Access Compliance Report

Public Rights-of-Way

Intersection ID: 5454	Main Street: PAVILION_BV	Cross Street: UNIVERSITY_CITY_BV	Location: NE
ADA ID: 6A8063A41BCF	Ramp Type: Perp	Initial Pass/Fail: Fail	Overall Compliance: No
Severity Score: 26.25			
Codes/Mitigation Info/Possible Solution		Field Measurements/Component Compliance

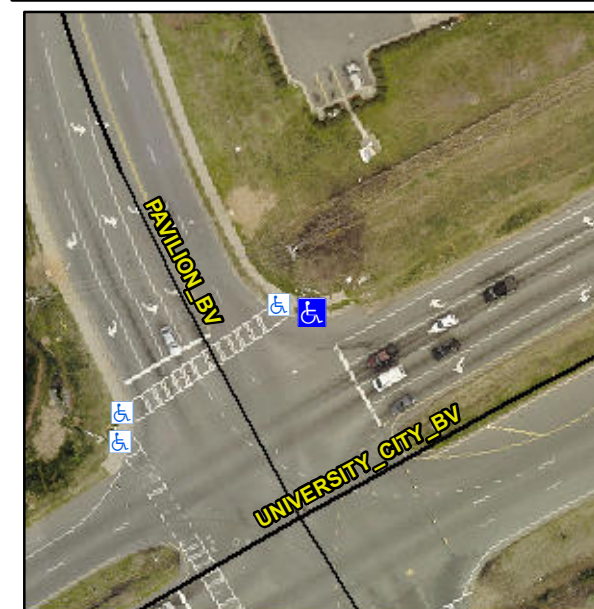
Not Found, R304.2.2, R304.5.3

Compliance	Description	Data	Compliance	Description	Data
N/A	Ramp Length (in)	96.0	No	Ramp Slope (%)	17.4
Yes	Ramp Width (in)	48.0	No	Ramp XSlope (%)	3.9
N/A	Flare Type LT	N/A	N/A	Flare Type RT	N/A
N/A	Flare Slope LT (%)	N/A	N/A	Flare Slope RT (%)	N/A
N/A	Flare Traversable LT?	N/A	N/A	Flare Traversable RT?	N/A
N/A	Landing Length (in)	N/A	N/A	DWS Provided?	N/A
N/A	Landing Width (in)	N/A	N/A	DWS Contrast?	N/A
N/A	Landing Slope (%)	N/A	N/A	DWS Length (in)	N/A
N/A	Landing X Slope (%)	N/A	N/A	DWS Full Width?	N/A
N/A	Landing Curb? (Y/N)	N/A	N/A	DWS Offset (in)	N/A
N/A	Shared Landing?	N/A			
N/A	Gutter Ponding?	N/A	N/A	Gutter Slope (%)	N/A
N/A	Gutter Lip Ht (in)	N/A	N/A	Gutter X Slope (%)	N/A
N/A	Painted X Walk1?	No	N/A	Painted X Walk2?	N/A
	X Walk 1 Direction	To S		X Walk 2 Direction	N/A
N/A	X Walk 1 Width (in)	N/A	N/A	X Walk 2 Width (in)	N/A
	X Walk 1 Slope (%)	2.3		X Walk 2 Slope (%)	N/A
	X Walk 1 X Slope (%)	2.7		X Walk 2 X Slope (%)	N/A

Remove & Replace Entire Ramp.
